COUNCIL ACTION FORM

SUBJECT: REZONING AND MAJOR SITE DEVELOPMENT PLAN FOR 3505 AND 3515 LINCOLN WAY

3515 R. 3505 LINCOLN WAY
 WALNUT RIDGE COMMERCIAL
 SITE LANDSCAPING PLAN

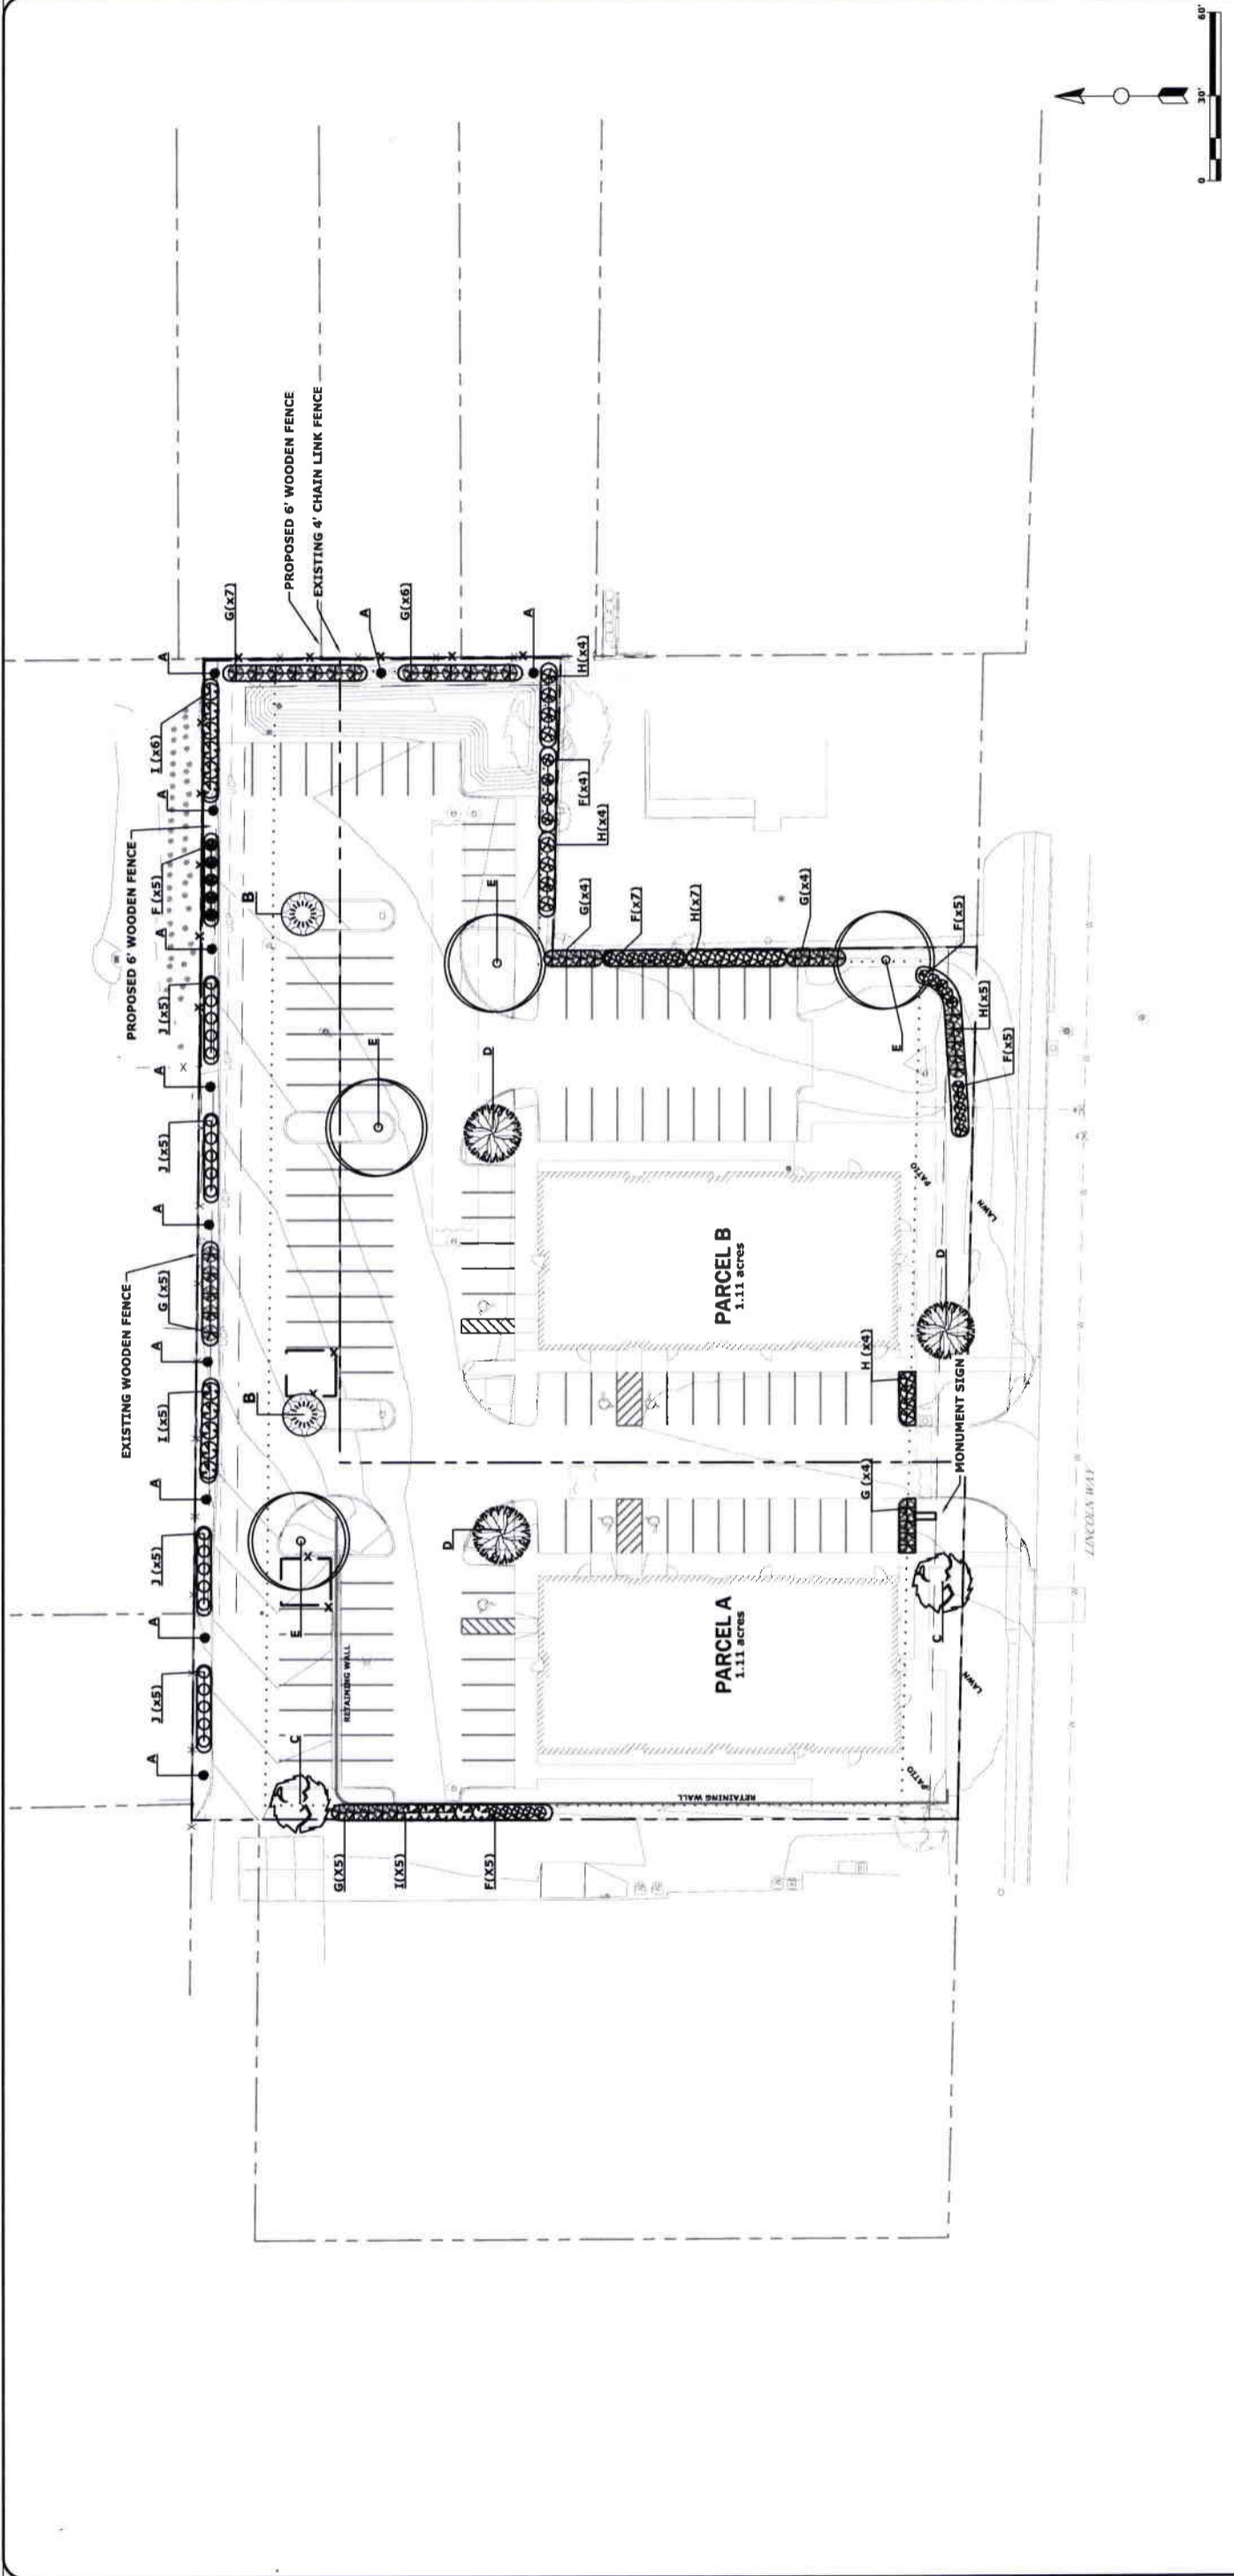
Per landscape standards, a 5-foot wide L3 screen (6-foot tall screen) is required for a parking lot screen along the north and east property lines abutting residentially zoned lots. This requirement includes the need for 1 landscape tree for every 50 lineal feet and shrubs spaced 6 feet on center. **The standard allows for the inclusion of a 6 foot fence to meet the requirement, allowing for a reduction in the shrubs at 1 per every 10 feet.** The applicant has proposed a fence to meet the L3 screen. A new fence is being proposed for most of the area, however, there is a portion of existing fence along the north lot line which is unclear who ownership belongs to. Staff believes utilizing this existing fence which is in good shape meets the intent of the standard, although not newly installed by the applicant. The applicant has agreed to maintain and replace the fence to keep compliance with the L3 screen so as to not install an additional fence along the lot line.

The proposed landscape trees (Taylor Juniper) have been noted by the Electric Department to exceed the height allowed under overhead power lines along the north and east property lines. A lower growing tree with a maximum mature height of 15' to 20' will need to be substituted to meet the requirement. Staff suggests the use of an ornamental or understory type tree, such as an evergreen tree or flowering tree like the Japanese Tree Lilac proposed on other areas of the site or even a type of crabapple tree to meet the screen requirement but to not interfere with overhead power lines Staff can work with the applicant to revise the plan accordingly. The parking lot landscaping includes planting of handful of taller maple trees that will provide some greater height of trees and screening further back from the property line.

- ii. Approval and recording of a Plat of Survey to create the identified parcels as depicted in the Major Site Development Plan;
 - iii. Revision of the landscape trees to substitute an understory tree type along the north and east property lines due to the presence of overhead power lines.
